Design Advisory Board

Tuesday, July 14, 2026, 3:00 PM

To: The Design Advisory Board
From: Mary O'Neil, AICP, Principal Planner
RE: ZP-26-28
Location: 45 Howard Street
Date: July 14, 2026

To: The Design Advisory Board
From: Mary O'Neil, AICP, Principal Planner
RE: ZP-26-216
Location: 124-126 North Avenue
Date: July 14, 2026

SITE PLAN
EXISTING LOT COVERAGE

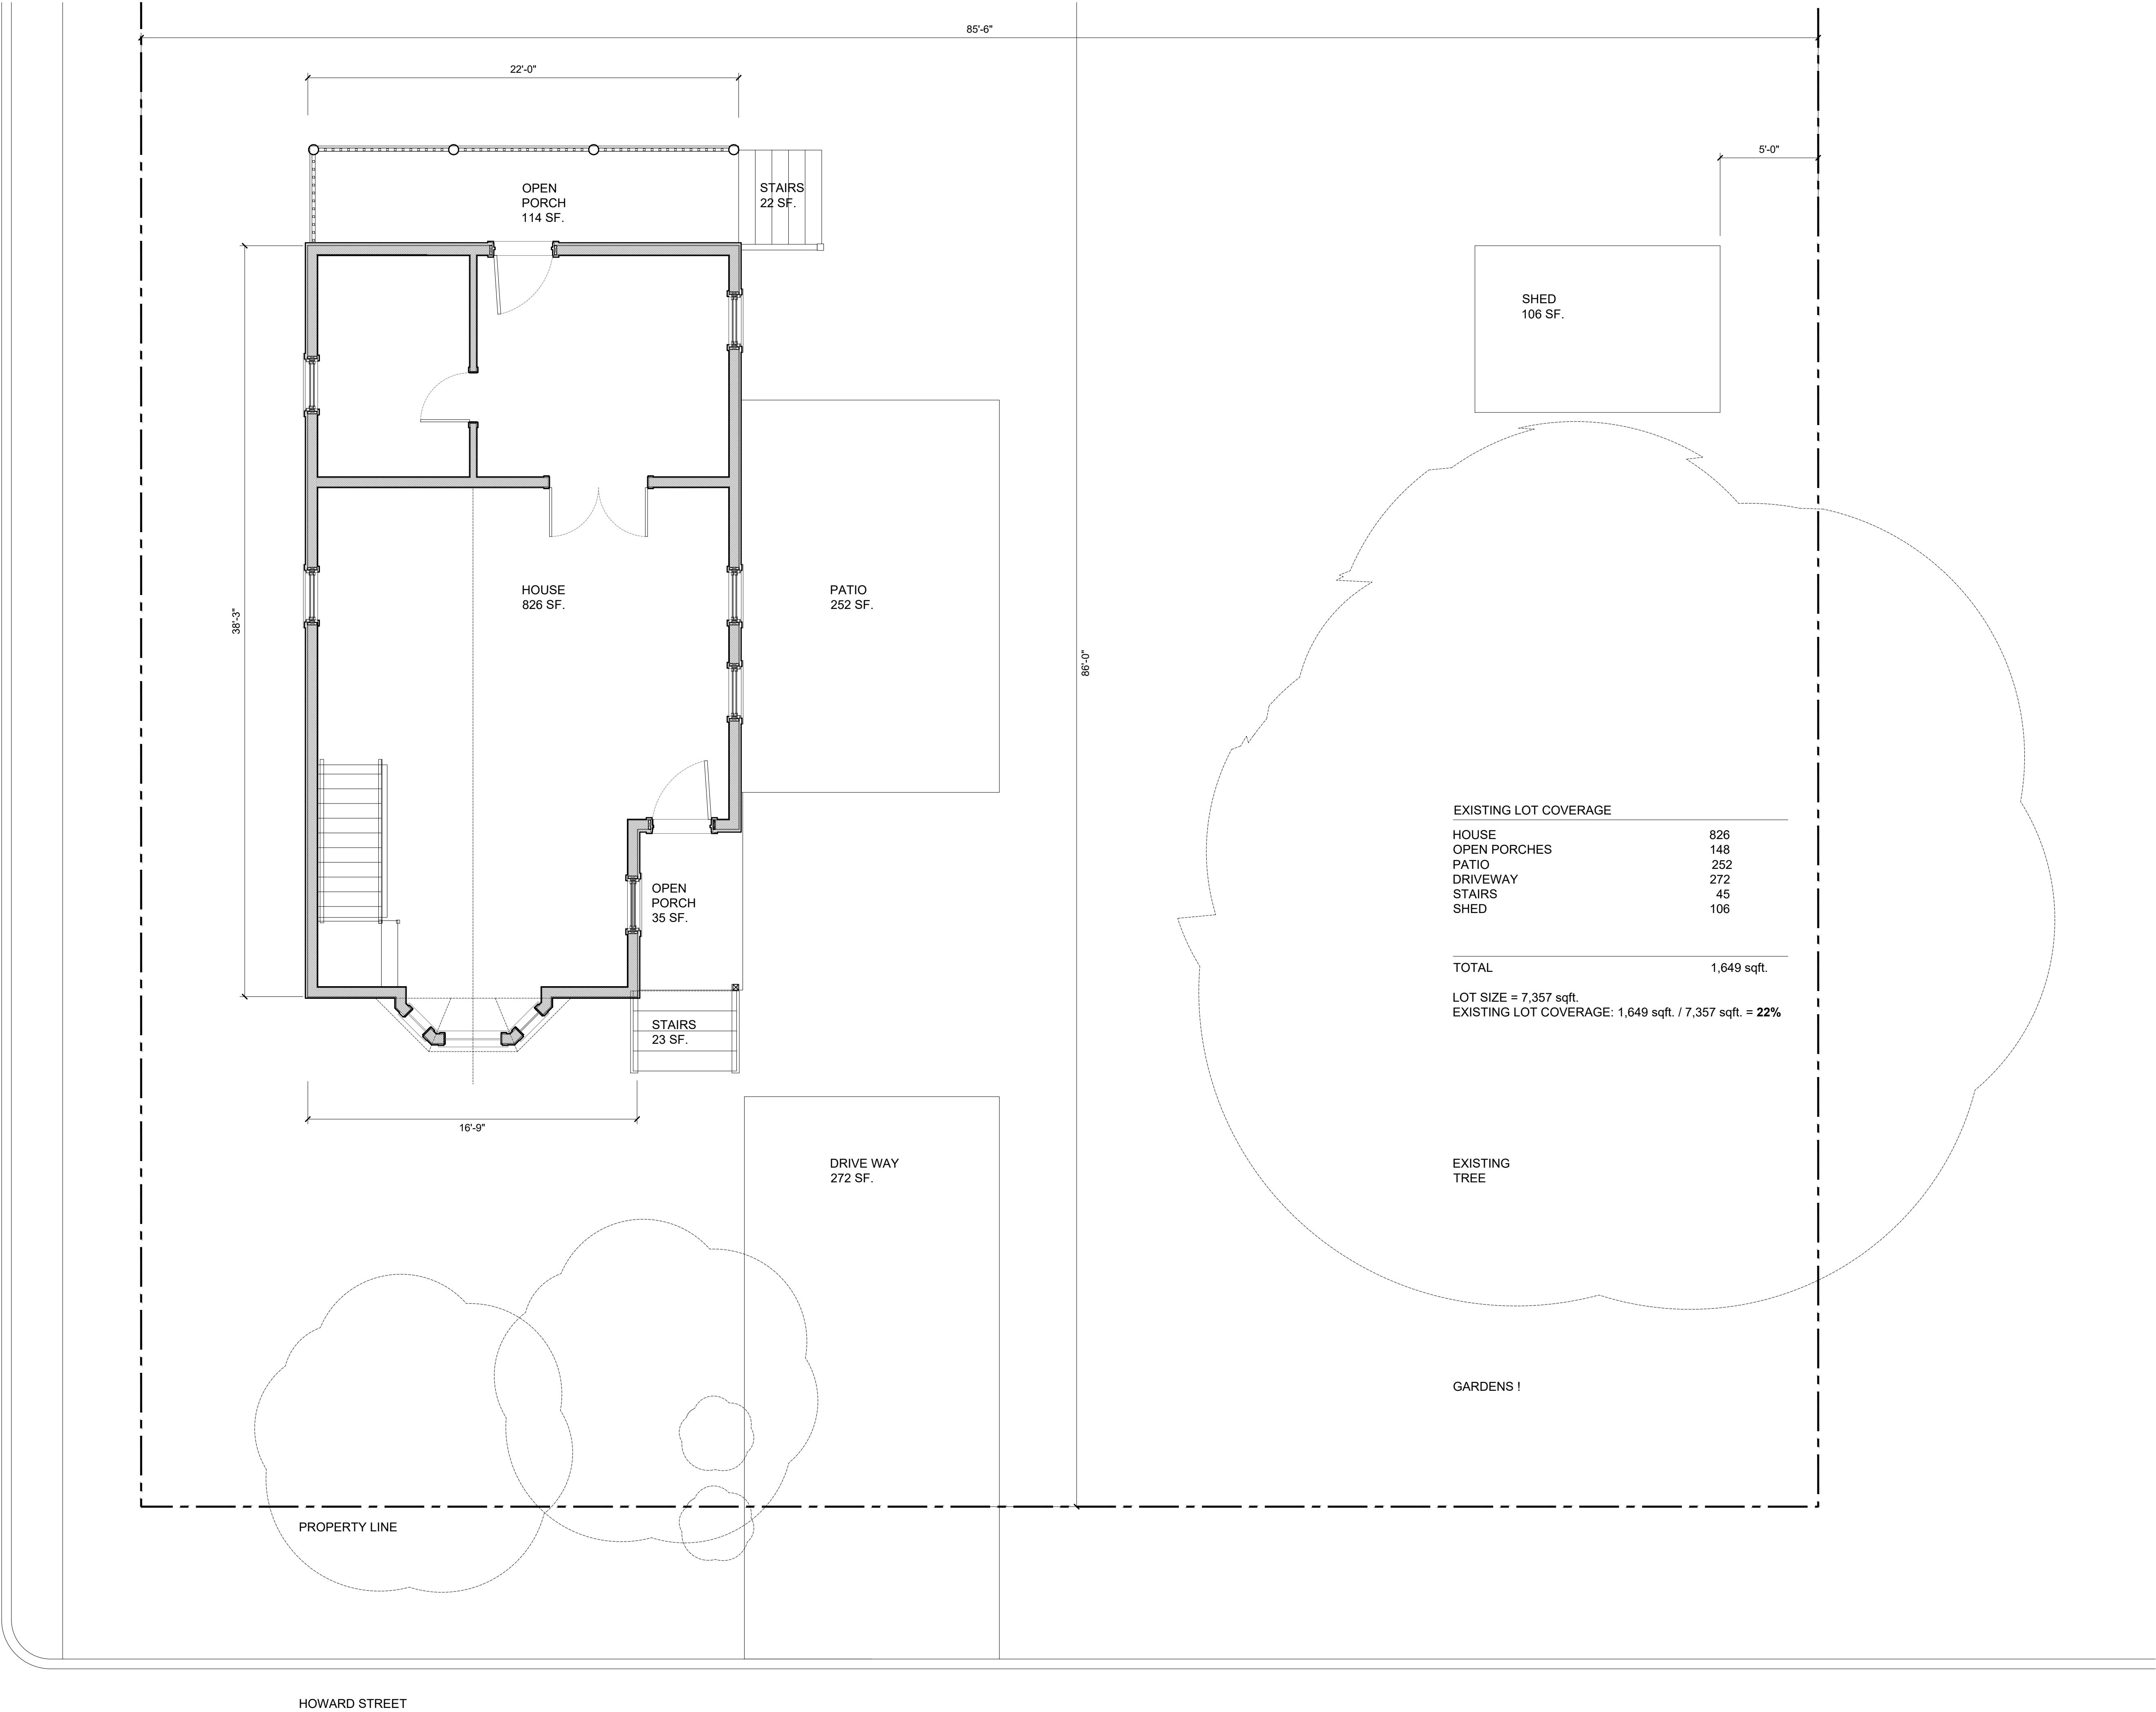
No fences or retaining walls are proposed. An existing, mature tree in the west shall will be retained. The site plan A 101. defines the intent or existence of gardens in the north/west of the yard.

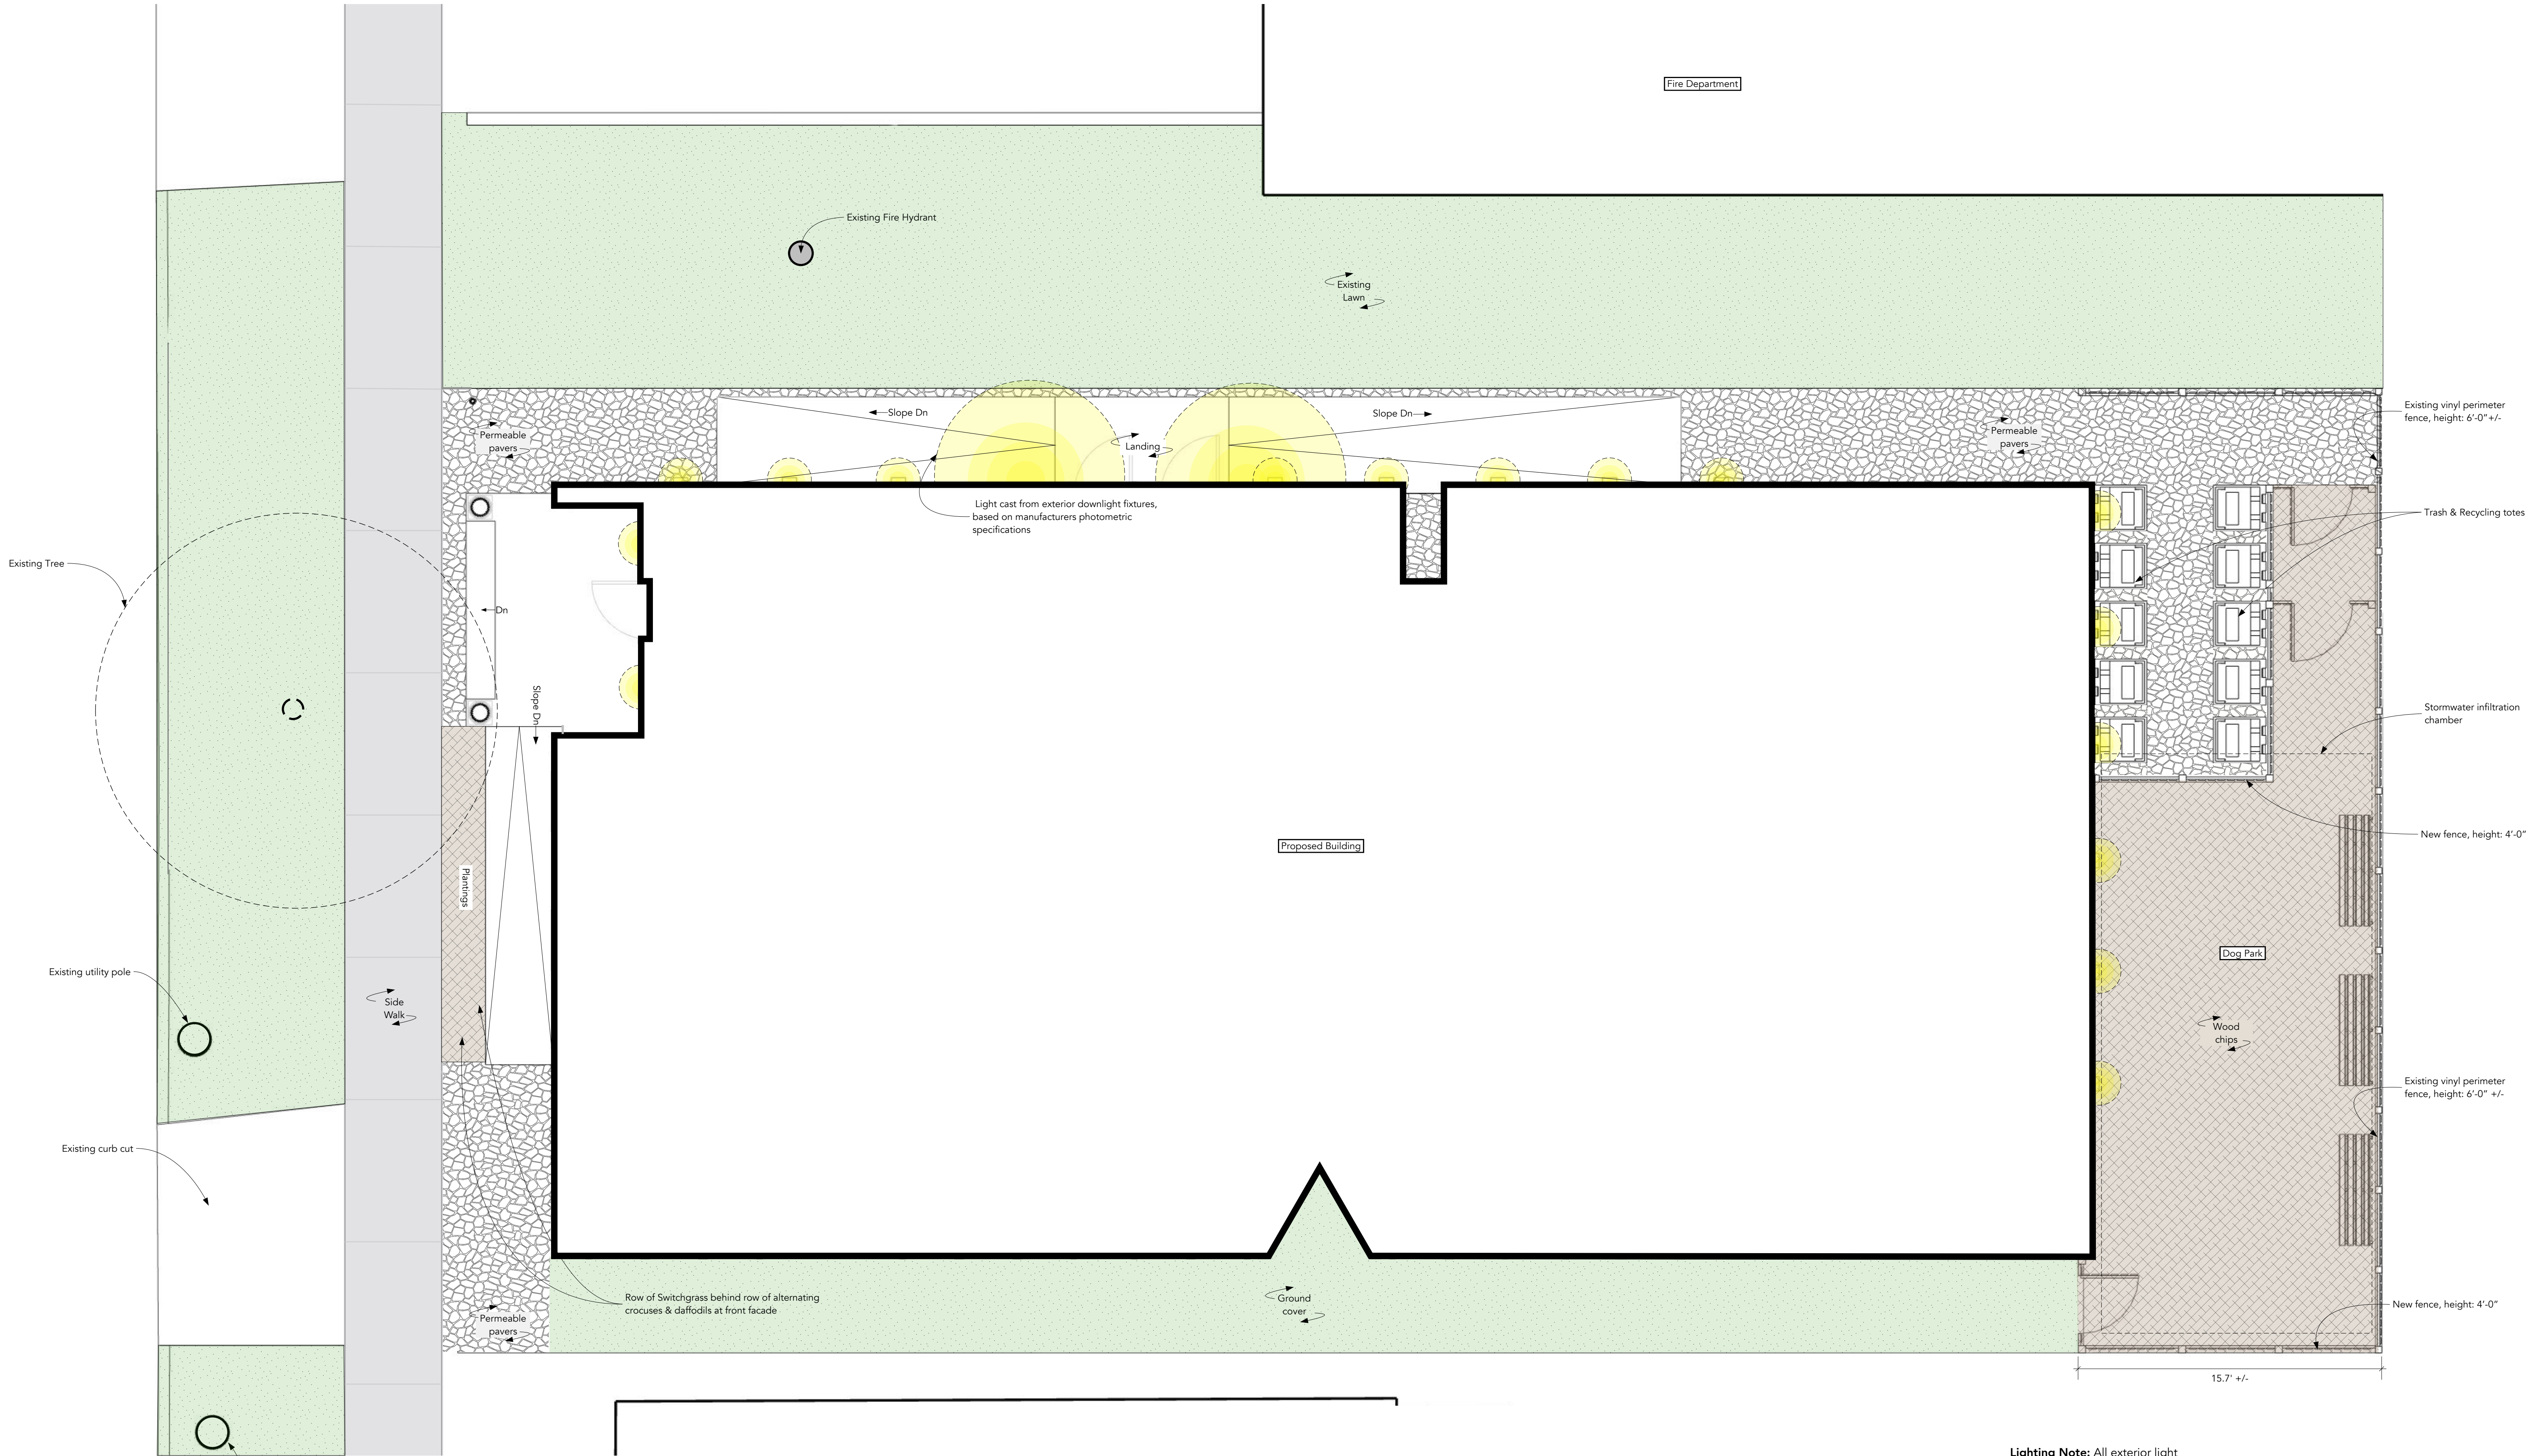
Schematic plans define a site to be graded to the east to accommodate the new building. See Plan A0.0 of submission document.

The access along the north elevation includes a gentle increasing grade that would appear to meet ADA access requirements. Similarly, plans indicate a grade increase/ramp at the primary entrance. See Plan A 0.0.

Plan EC1.0 defines the intended removal of a mature (maple?) tree in the rear yard. No other new trees are proposed.

Plan A).1 defines minor plantings along a very narrow bed adjacent to the public sidewalk. The daffodils and crocus will be seasonal; the switchgrass is a perennial if it survives next to the sidewalk. South of the building "ground cover" is proposed. If Blue Star Creeper is the proposed planting, it must be sustained to assure the 20% green space required by the zoning district. (10% if lot coverage bonus for IZ is realized.)

1 Plan - First Floor
Scale: 1/8" = 1'-0"

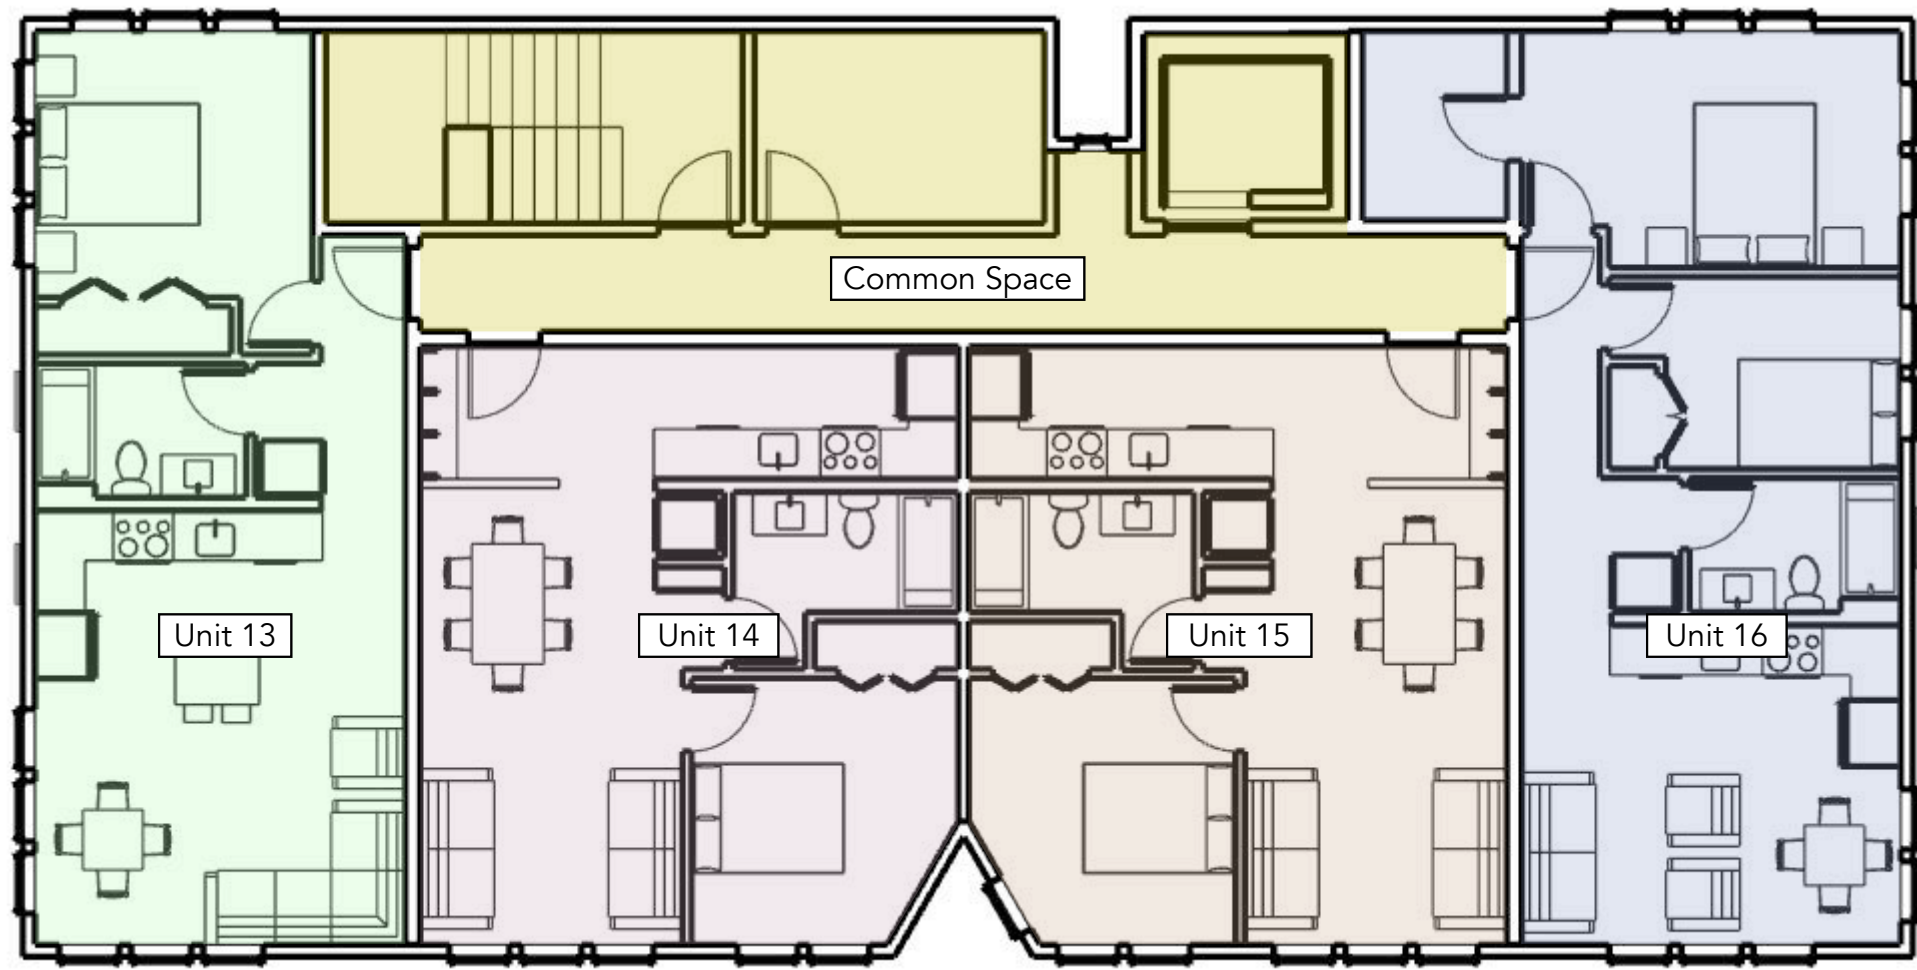
Plan A 1.1 defines a first-floor storage room for bicycle parking; however estimated capacity is 5 spaces. 5 more Long term and 2 short term spaces must be identified.

There is an interior mailroom (Plan A1.1.) A utility vault is proposed below the sidewalk within the ROW; approval must be secured from the Department of Public Works and BED for this location as it is outside the parcel area and will involve digging in the ROW. No meters or utility connections are illustrated on plans.
